Background

Field Corrective Action

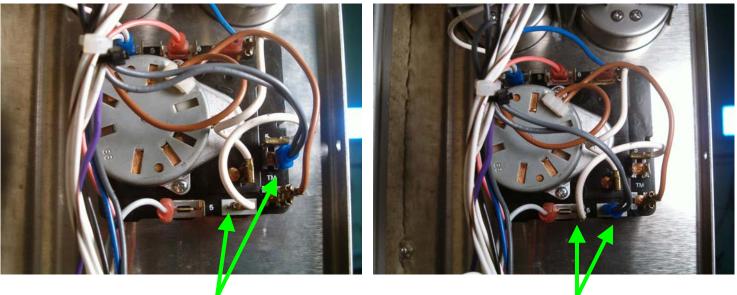
There have been recent instances of the steamer timer (AT0E-2297, all timer models) not sounding off at the end of a timed cycle. Investigation with the supplier revealed a wiring issue with the timer motor wiring. The root cause was that the timer motor was disabled before the timer could complete its timing sequence, resulting in intermittent buzzer operation. AccuTemp is taking corrective action steps to resolve this issue with the supplier and at its factory.

1) Move the gray wire pair, as shown, from the right side terminal #5 to the bottom side terminal #5 (timer shown in mounted orientation).

2) Move the white wire, as shown, from the bottom side terminal #5 to the bottom side terminal #4 (timer shown in mounted orientation).
